The Commission has issued the enclosed Amendment No. 35 to Facility Operating License No. DPR-58 and Amendment No. 16 to Facility Operating License No. DPR-74 for the Donald C. Cook Nuclear Plant, Unit Nos. 1 and 2, respectively. The amendments consist of changes to the Technical Specifications in response to your application transmitted by letter dated August 9, 1979, as supplemented December 7, 1979.

These amendments provide for the addition of a safety-related DC battery system to upgrade the turbine driven train of the auxiliary feedwater system, the upgrading of the Technical Specifications for existing safety-related batteries and the removal of a Unit 2 license condition which has been satisfied by elimination of AC dependency in the turbine driven train of the Unit 2 auxiliary feedwater system.

SAFETY EVALUATION BY THE OFFICE OF NUCLEAR REACTOR REGULATION
RELATED TO AMENDMENT NO. 35 TO FACILITY OPERATING LICENSE NO. DPR-58
AND AMENDMENT NO. 16 TO FACILITY OPERATING LICENSE NO. DPR-74

INDIANA AND MICHIGAN ELECTRIC COMPANY
DONALD C. COOK NUCLEAR PLANT UNIT NOS. 1 AND 2
DOCKET NOS. 50-315 AND 50-316

Auxiliary Feedwater System
D.C. Cook
Figure 1 (Sheet 1 of 2)

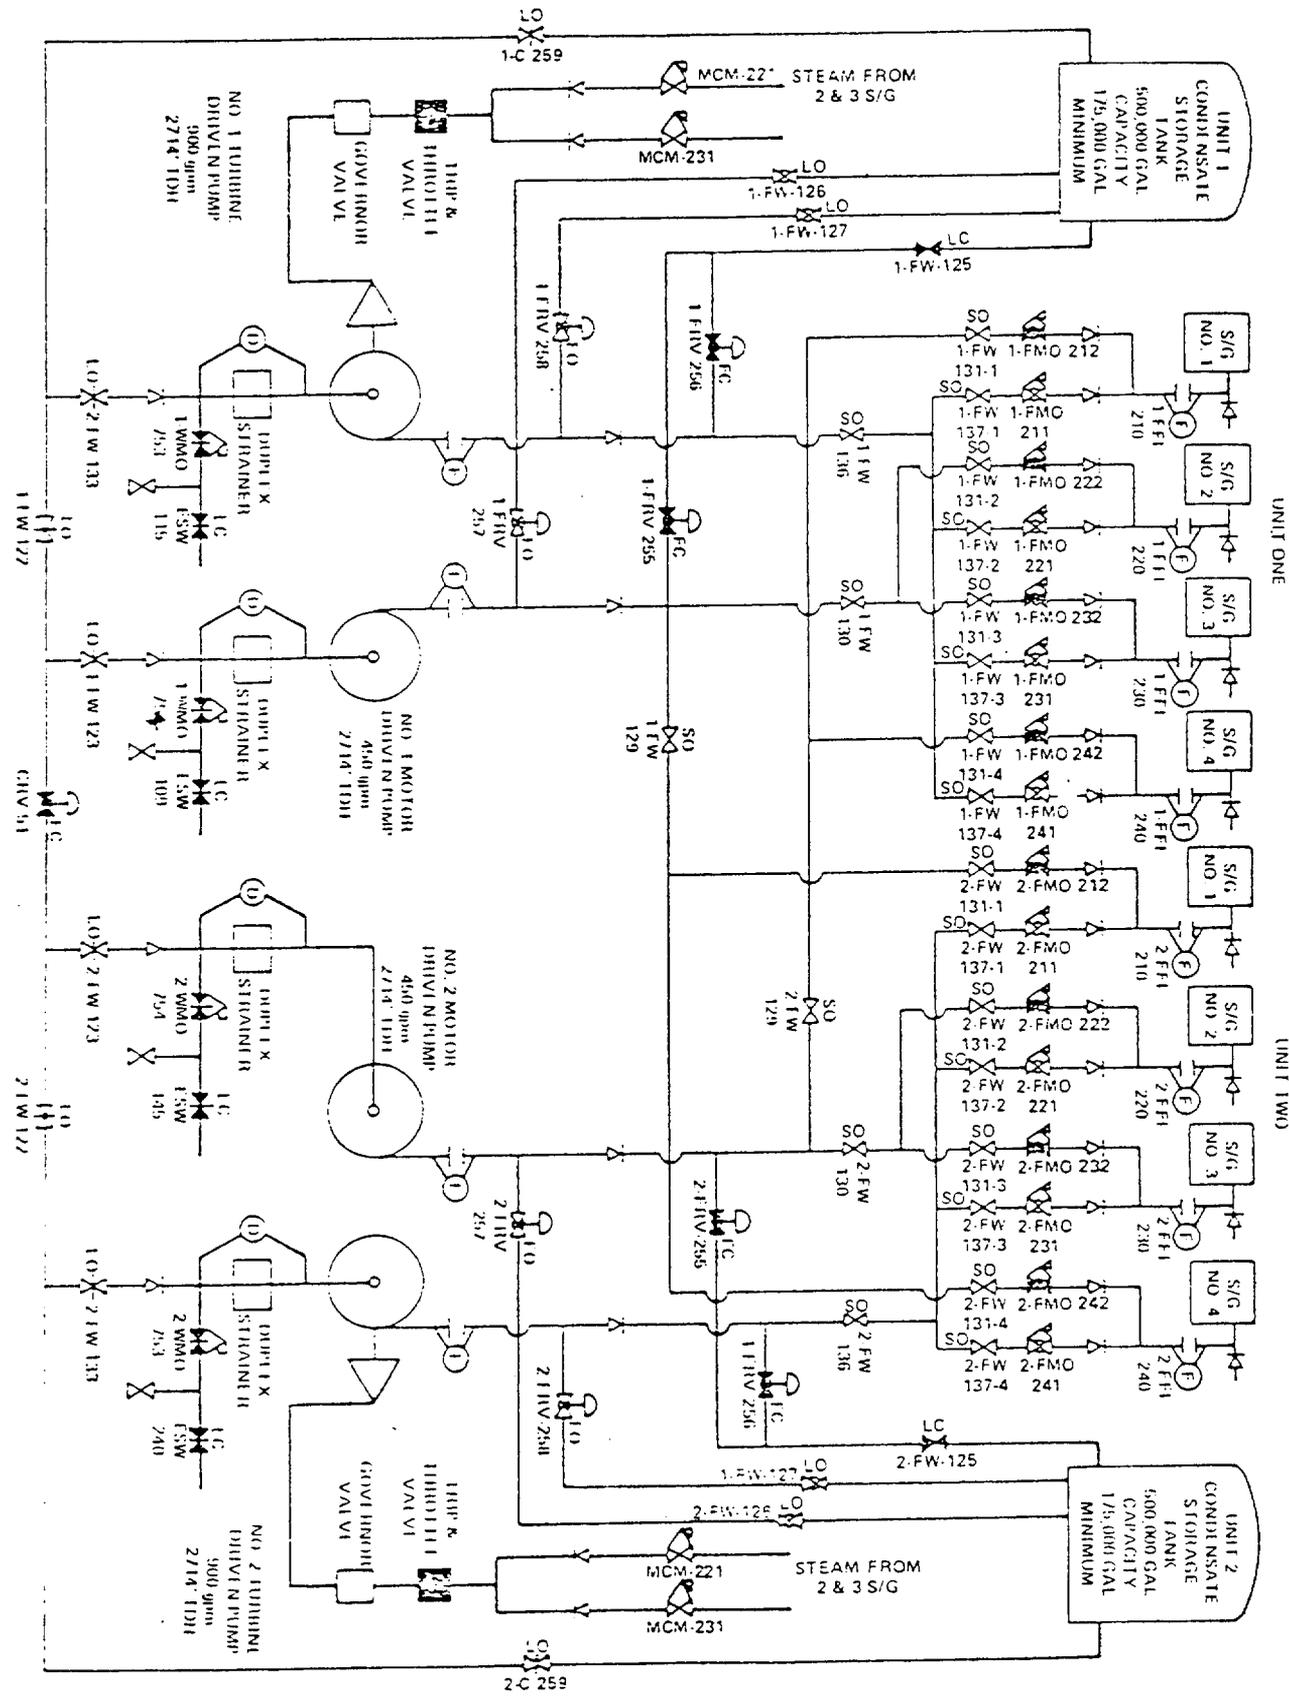
Existing Turbine Driven Auxiliary Feedwater Train - Unit 2

The turbine driven auxiliary feedwater (TDAFW) pump is connected to all four steam generators in Unit 2. Steam is supplied redundantly from Steam Generator Nos. 2 and 3 and taken upstream of the main steam isolation valves. The steam supply isolation valves to the TDAFW pump are MCM 221 and MCM 231; (refer to Figure 1). These 4-inch motor operated gate valves are normally open, allowing steam pressure to be available up to the trip and throttle (T&T) valve. The motor operated steam isolation valves MCM-221 and 231 can be opened or closed from the control room and on loss of power they fail as-is.

The T&T valve is normally closed and opens automatically when the TDAFW pump receives a start signal, however, it is AC powered and fails as-is. Auxiliary feedwater is supplied to the four steam generators through 4-inch motor operated valves (MOV), FMO-211, 221, 231, and 241. These globe type MOVs are normally open, but each may be closed by the control room operator in the event of a feedwater or steam line break at the steam generator it feeds. Each MOV can be throttled to regulate steam generator level. In the event of a steam line break and rapid depressurization of a steam generator, or upon detection of a high flow at the TDAFW pump, these MOVs are automatically driven to an intermediate position to prevent pump runout. On loss of power, these MOVs fail as-is.

The TDAFW pumps and associated valves are presently powered from the Class IE AC power system train B. Upon loss of all AC both onsite and offsite the AFWS could not perform its intended function. Therefore, the staff has found it necessary and the licensee has committed to eliminate dependence of the TDAFW pump train upon alternating current by converting to a direct current source of power.

At the present time, Unit 2 has two safety-related station batteries. However, when the additional motor driven auxiliary feedwater (MDAFW) pump (proposed for future installation by the licensee) is installed, the use of either of these batteries for the TDAFW pump train will not be possible. At that time, each of the two MDAFW pumps will be served by its own ESF electrical train and associated station battery. Hence, the licensee has installed a third station battery, designated as train "N". This new train "N" station battery is considered to be part of the ESF system.

The turbine driven auxiliary feed pump control bus and associated MOV motors will be powered from the "N" train battery. The following is a list of loads on the "N" train: valve - FMO - 211, 221, 231 and 241 (1.6 Hp) each; the trip and throttle valve (0.33 Hp); test valve - FRV - 256; emergency leak off valve - FRV - 258; AFW Turbine Auto Start; AFW turbine trip; and the overspeed monitor.

Two battery chargers are connected to the "N" train battery bus. When AC power is available, each charger has sufficient capacity to supply all steady state "N" train loads and recharge the battery from full discharge (1.75 volts per cell) to full charge in 24 hours. Only one of the chargers will be in service at any one time. The battery is capable of serving all of the electrical needs of the TDAFW pump train for at least four hours upon loss of all AC power.

The two new battery chargers would be powered from separate and independent Class IE power buses. As originally proposed, either charger could have been connected to the "N" train battery under normal conditions. During our review we identified the potential for unacceptable parallel operation of both chargers which could connect redundant safety load groups in violation of Regulatory Guide 1.5. We required that at least one interlock (mechanical or electrical) be provided to prevent an operator error that would parallel these chargers. The licensee modified its design to incorporate an acceptable electrical interlock which will prevent this potential problem.

Likewise, during our review we identified another potential for paralleling two standby circuits from the existing station batteries (AB and CD) in violation of Regulatory Guide 1.6. We required that at least one interlock be provided to prevent operator error from tying these batteries together. To meet our requirement, the licensee disabled the backup feeders from the AB and CD batteries (by disconnecting and insulating the ends of the interconnecting cables). These cables were disconnected at the "N" train distribution cabinet and at the distribution cabinets for the AB and CD batteries.

With the incorporation of these modifications we conclude that the design of the TDAFW pump train complies with the provisions of Regulatory Guide 1.6.

- (1) The design bases information provided gives reasonable assurance that the new DC train can be satisfactorily implemented into the existing AFWs.
- (2) The "N" battery train is physically and electrically independent from the other ESF electrical trains.

- (3) The conversion of the TDAFW pump train from AC to DC meets the Commission's requirements and is acceptable.
- (4) The "N" battery train is capable of serving the TDAFW pump train for at least four hours without either charger in operation. This feature satisfies the staff position that at least one AFW flow path and associated instrumentation and controls be capable of being operated without AC power for at least two hours.
- (5) The fire protection for the rooms containing the "N" battery train meets the requirements of Appendix A to Branch Technical Position APCSB 9.5-1.
